POWER PLANT - ENGINE - EEC LINK HARNESS-CORE AND EGT HARNESS - INTRODUCTION OF IMPROVED
CLIPS FOR HARNESS CLIPPING - CATEGORY CODE 4 - MOD.ENG-71-0054

- (1) Aircraft: Airbus A320
- (2) Engine: V2500-A1 Engines prior to V0093

V2500-ENG-71-0054

Location of clipping points on the EEC link harness-core
Fig.1

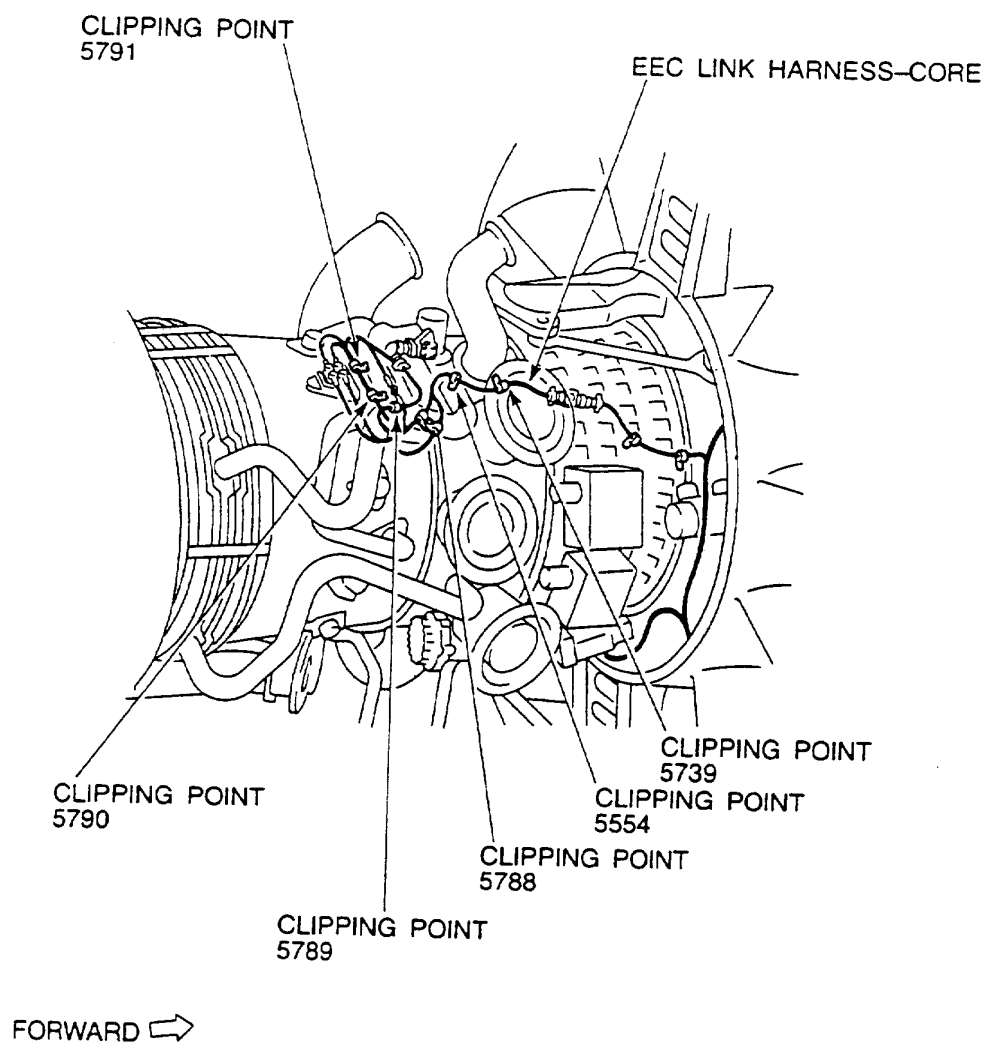
- (a) All 471 type clips used for EEC link harness-core clipping and EGT harness clipping are superseded by TA0210046FT type or ST1455 type clips.
- (b) All 471-4 clips used for EGT harness clipping are changed to large size clips, TA0210046FT05 or ST1455-05 clips.
- (c) 471-7 clip used at clipping point CP3735 is changed to small size clip, TA0210046FT05 or ST1455-05 clip.

Replacement of clips for EEC link harness-core clipping
FIG.2 (Sheet 1 of 2)

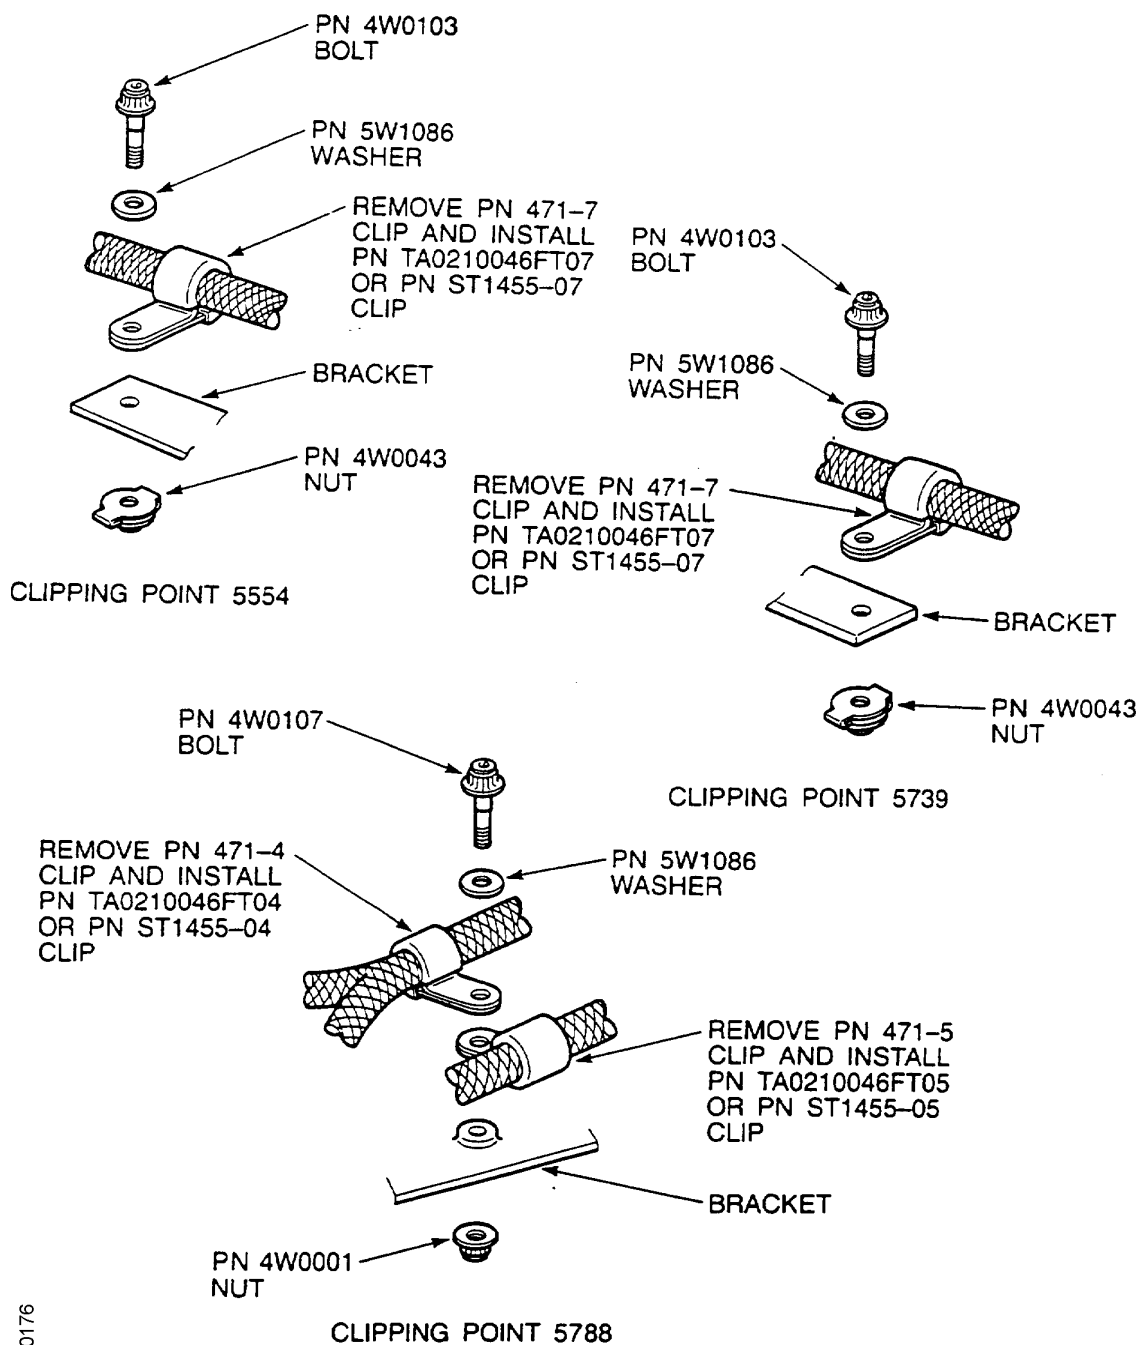
- (1) Replace old clip to new clip at clipping point 5554
 - (a) Remove 4W0043 Nut, 5W1086 Washer and 4W0103 Bolt to release 471-7 Clip on the EEC link harness-core.

- (b) Remove 471-7 Clip from the EEC link harness-core and install TA0210046FT07 or ST1455-07 Clip to the EEC link harness-core.
 - (c) Install the clip using 4W0103 Bolt, 5W1086 Washer and 4W0043 Nut.

- (d) Torque the bolt to 36 to 45 lbfin (4 to 5 Nm).
- (2) Replace old clip to new clip at clipping point 5739
 - (a) Remove 4W0043 Nut, 5W1086 Washer and 4W0103 Bolt to release 471-7 Clip on the EEC link harness-core.

- (b) Remove 471-7 Clip from the EEC link harness-core and install TA0210046FT07 or ST1455-07 Clip to the EEC link harness-core.
 - (c) Install the clip using 4W0103 Bolt, 5E1086 Washer and 4W0043 Nut.

- (d) Torque the bolt to 36 to 45 lbfin (4 to 5 Nm).
- (3) Replace old clips to new clips at clipping point 5788
 - (a) Remove 4W0001 Nut, 5W1086 Washer and 4W0107 Bolt to release 471-5 and 471-4 Clips on the EEC link harness-core.

- (b) Remove 471-5 Clip from the EEC link harness-core and install TA0210046FT05 or ST1455-05 Clip to the EEC link harness-core.
- (c) Remove 472-4 Clip from the EEC link harness-core and install TA0210046FT04 or ST1455-04 Clip to the EEC link harness-core.

Replacement of clips for EEC link harness-core clipping
Fig.2 (Sheet 2 of 2)

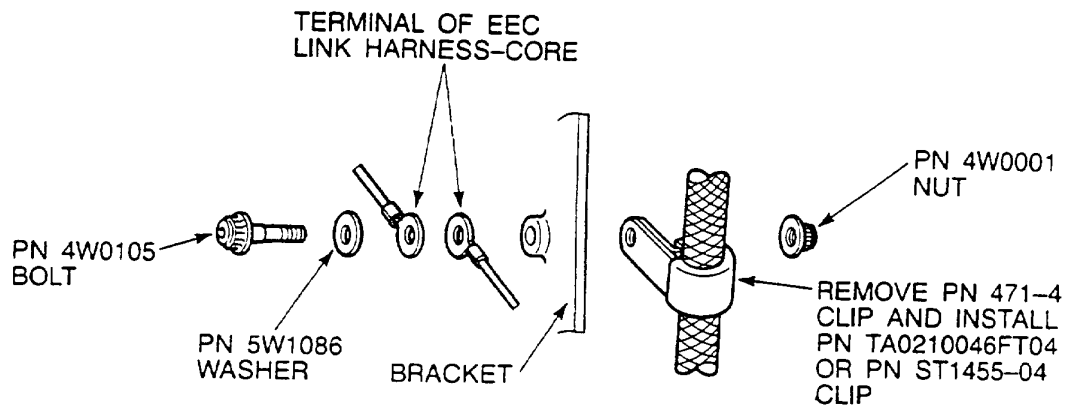
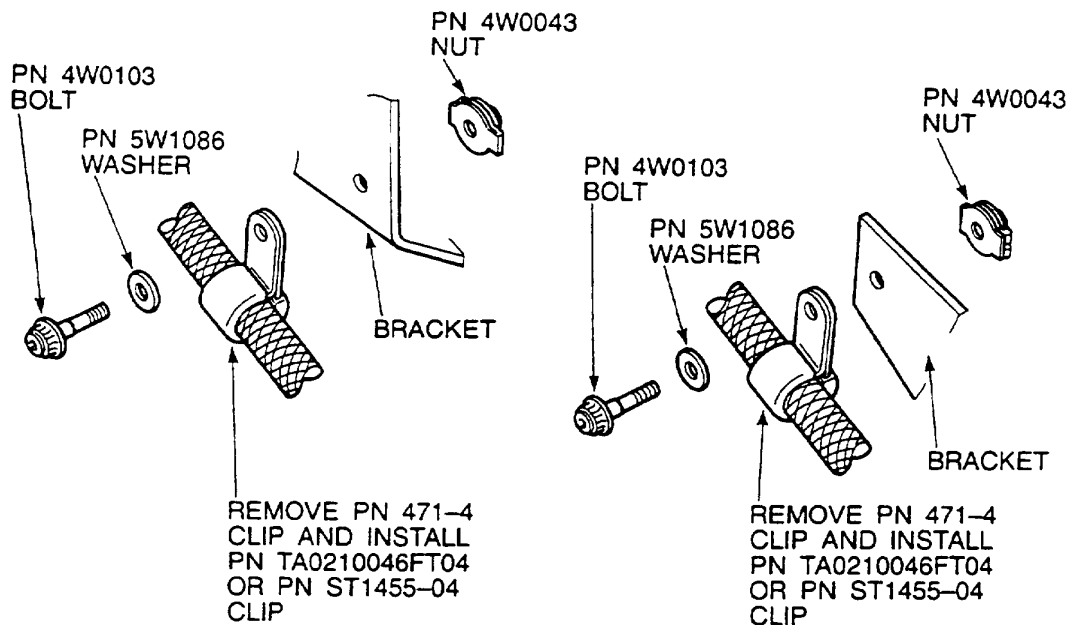
- (d) Install the clips using 4W0107 Bolt, 5W1086 Washer and 4W0001 Nut.
- (e) Torque the nut to 36 to 45 lbfin (4 to 5 Nm).
- (4) Replace old clip to new clip at clipping point 5789

- (a) Remove 4W0001 Nut, 5W1086 Washer and 4W0105 Bolt to release 471-4 Clip on the EEC link harness-core and terminals of the EEC link harness-core.
 - (b) Remove 471-4 Clip from the EEC link harness-core and install TA0210046FT04 or ST1455-04 Clip to the EEC link harness-core.

- (c) Install the clip and the terminals using 4W0105 Bolt, 5W1086 Washer and 4W0001 Nut.
 - (d) Torque the nut to 36 to 45 lbfin (4 to 5 Nm).
- (5) Replace old clip to new clip at clipping point 5790

- (a) Remove 4W0043 Nut, 5W1086 Washer and 4W0103 Bolt to release 471-4 Clip on the EEC link harness-core.
 - (b) Remove 471-4 Clip from the EEC link harness-core and install TA0210046FT04 or ST1455-04 Clip to the EEC link harness-core.

- (c) Install the clip using 4W0103 Bolt, 5W1086 Washer and 4W0043 Nut.
 - (d) Torque the bolt to 36 to 45 lbfin (4 to 5 Nm).
- (6) Replace old clip to new clip at clipping point 5791

- (a) Remove 4W0043 Nut, 5W1086 Washer and 4W0103 Bolt to release 471-4 Clip on the EEC link harness-core.
 - (b) Remove 471-4 Clip from the EEC link harness-core and install TA0210046FT04 or ST1455-04 Clip to the EEC link harness-core.

- (c) Install the clip using 4W0103 Bolt, 5W1086 Washer and 4W0043 Nut.
 - (d) Torque the bolt to 36 to 45 lbfin (4 to 5 Nm).
- (7) Replace old clip to new clip at clipping point 5211

Replacement of clips for EGT harness clipping
Fig.4 (Sheet 1 of 6)

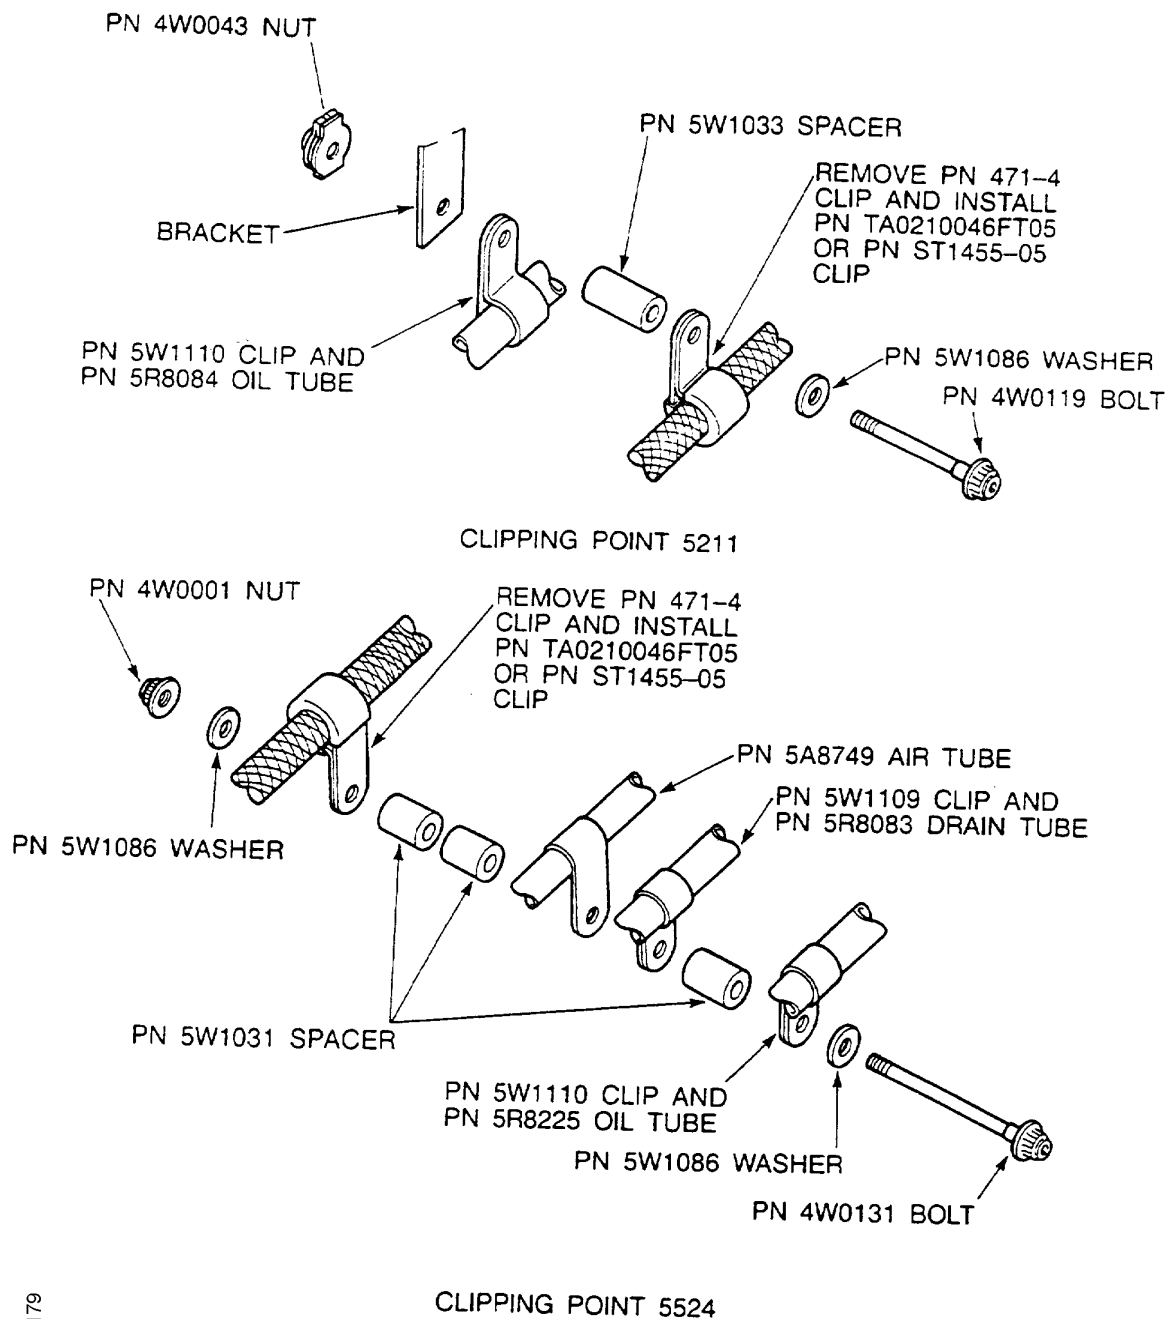
- (a) Remove 4W0043 Nut, 5W1033 Spacer, 5W1086 Washer and 4W0119 Bolt to release 471-4 Clip on the EGT harness and 5W1110 Clip on the oil tube.
 - (b) Remove 471-4 Clip from the EGT harness and install TA0210046FT05 or ST1455-05 Clip to the EGT harness.

- (c) Install the clips using 4W0119 Bolt, 5W1086 Washer, 5W1033 Spacer and 4W0043 Nut.
 - (d) Torque the bolt to 36 to 45 lbfin (4 to 5 Nm).
- (8) Replace old clip to new clip at clipping point 5524

- (a) Remove 4W0001 Nut, two 5W1086 Washers, three 5W1031 Spacers and 4W0131 Bolt to release 471-4 Clip on the EGT harness, 5W1110 Clip on the oil tube and 5W1109 Clip on the drain tube.

- (b) Remove 471-4 Clip from the EGT harness and install TA0210046FT05 or ST1455-05 Clip to the EGT harness.
 - (c) Install the clips using 4W0131 Bolt, two 5W1086 washers, three 5W1031 Spacers and 4W0001 Nut.

- (d) Torque the nut to 36 to 45 lbfin (4 to 5 Nm).
- (9) Replace old clip to new clip at clipping point 5526
- (a) Remove 4W0001 Nut, 5W1086 Washer, 5W1031 Spacer and 4W0113 Bolt to release 471-4 Clip on the EGT harness and 5W1109 Clip on the air tube.

- (b) Remove 471-4 Clip from the EGT harness and install TA0210046FT05 or ST1455-05 Clip to the EGT harness.
 - (c) Install the clips using 4W0113 Bolt, 5W1086 Washer, 5W1031 Spacer and 4W0001 Nut.

Replacement of clips for EGT harness clipping
Fig.4 (Sheet 2 of 6)

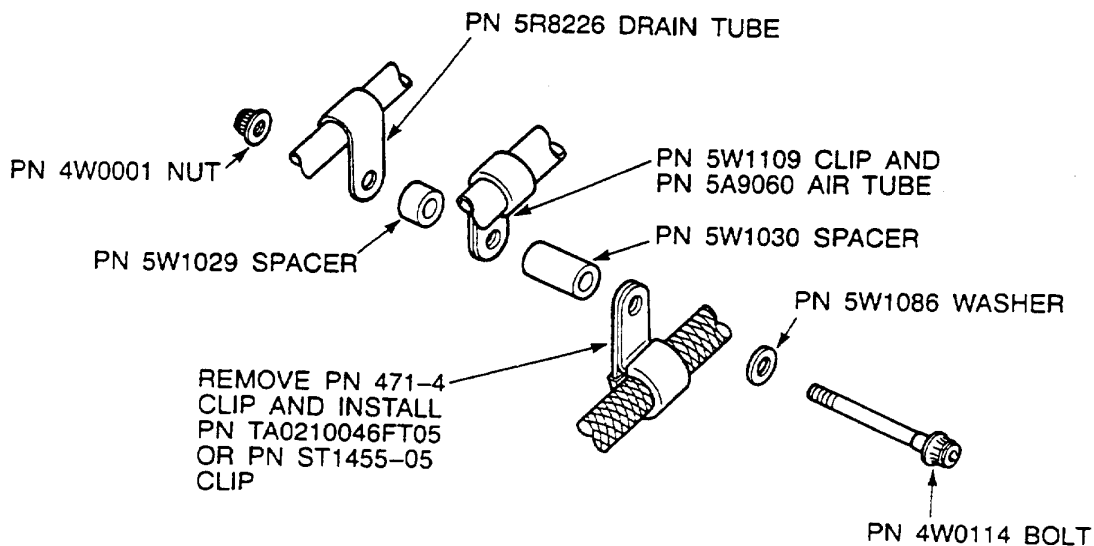
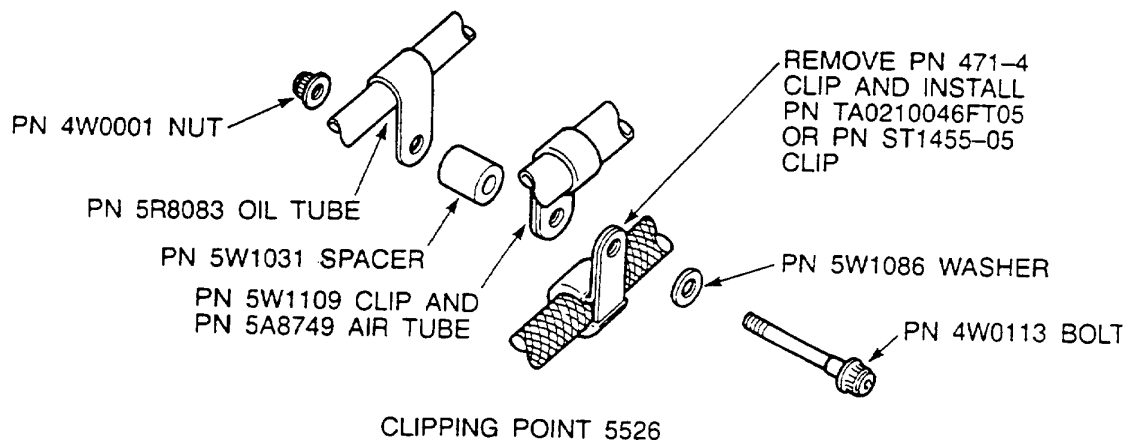
- (d) Torque the nut to 36 to 45 lbfin (4 to 5 Nm).
- (10) Replace old clip to new clip at clipping point 5527
- (a) Remove 4W0001 Nut, 5W1086 Washer, 5W1030 Spacer, 5W1029 Spacer and 4W0114 Bolt to release 471-4 Clip on the EGT harness and 5W1109 Clip on the air tube.

- (b) Remove 471-4 Clip from the EGT harness and install TA0210046FT05 or ST1455-05 Clip to the EGT harness.

- (c) Install the clips using 4W0114 Bolt, 5W1086 Washer, 5W1030 Spacer and 4W0001 Nut.
 - (d) Torque the nut to 36 to 45 lbfin (4 to 5 Nm).
- (11) Replace old clip to new clip at clipping point 5529

Replacement of clips for EGT harness clipping
Fig.4 (Sheet 4 of 6)

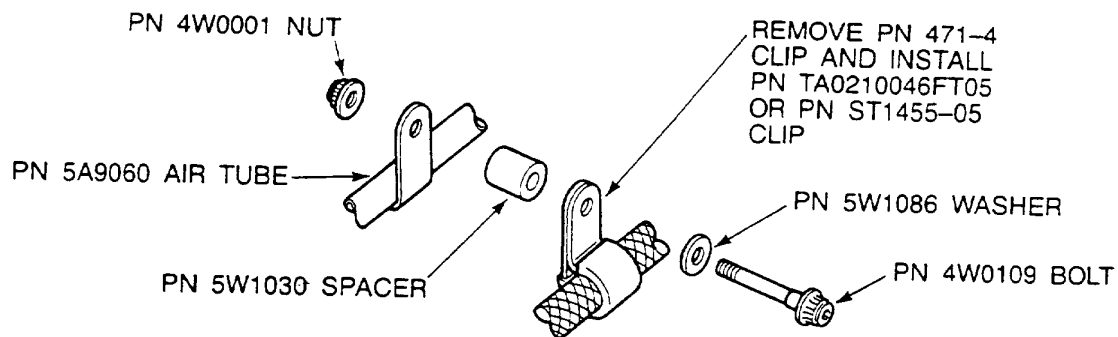
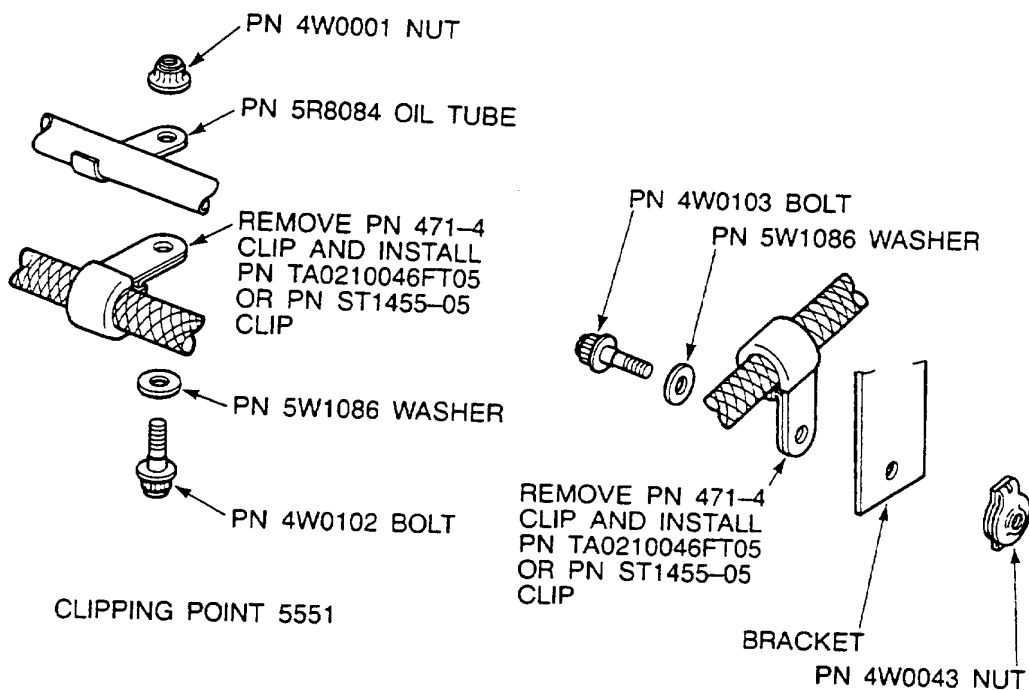
- (a) Remove 4W0001 Nut, 5W1086 Washer, 5W1030 Spacer and 4W0109 Bolt to release 471-4 Clip on the EGT harness.
 - (b) Remove 471-4 Clip from the EGT harness and install TA0210046FT05 or ST1455-05 Clip to the EGT harness.

- (c) Install the clip using 4W0109 Bolt, 5W1086 Washer, 5W1030 Spacer and 4W0001 Nut.
 - (d) Torque the nut to 36 to 45 lbfin (4 to 5 Nm).
- (15) Replace old clip to new clip at clipping point 5551

- (a) Remove 4W0001 Nut, 5W1086 Washer and 4W0102 Bolt to release 471-4 Clip on the EGT harness.
 - (b) Remove 471-4 Clip from the EGT harness and install TA0210046FT05 or ST1455-05 Clip to the EGT harness.

- (c) Install the clip using 4W0102 Bolt, 5W1086 Washer and 4W0001 Nut.
 - (d) Torque the nut to 36 to 45 lbfin (4 to 5 Nm).
- (16) Replace old clip to new clip at clipping point 5552

- (a) Remove 4W0043 Nut, 5W1086 Washer and 4W0103 Bolt to release 471-4 Clip on the EGT harness.
 - (b) Remove 471-4 Clip from the EGT harness and install TA0210046FT05 or ST1455-05 Clip to the EGT harness.

- (c) Install the clip using 4W0103 Bolt, 5W1086 Washer and 4W0043 Nut.
 - (d) Torque the bolt to 36 to 45 lbfin (4 to 5 Nm).
- (17) Replace old clip to new clip at clipping point 5553

Replacement of clips for EGT harness clipping
Fig.4 (Sheet 6 of 6)

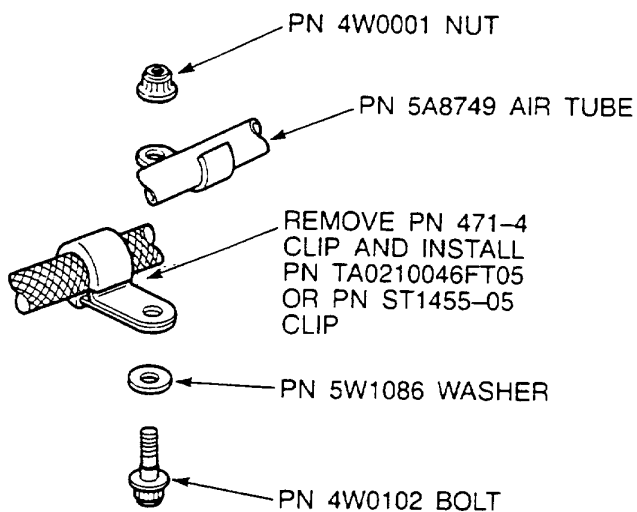
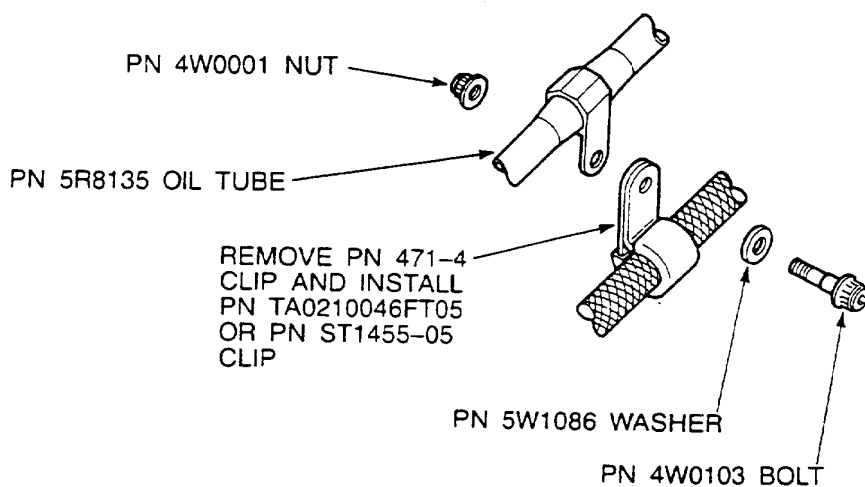
- (a) Remove 4W0001 Nut, 5W1086 Washer and 4W0102 Bolt to release 471-4 Clip on the EGT harness.
 - (b) Remove 471-4 Clip from the EGT harness and install TA0210046FT05 or ST1455-05 Clip to the EGT harness.

- (c) Install the clip using 4W0102 Bolt, 5W1086 Washer and 4W0001 Nut.
 - (d) Torque the nut to 36 to 45 lbfin (4 to 5 Nm).
- (21) Replace old clip to new clip at clipping point 5781

- (a) Remove 4W0001 Nut, 5W1086 Washer and 4W0103 Bolt to release 471-4 Clip on the EGT harness.
 - (b) Remove 471-4 Clip from the EGT harness and install TA0210046FT05 or ST1455-05 Clip to the EGT harness.

- (c) Install the clip using 4W0103 Bolt, 5W1086 Washer and 4W0001 Nut.
 - (d) Torque the nut to 36 to 45 lbfin (4 to 5 Nm).
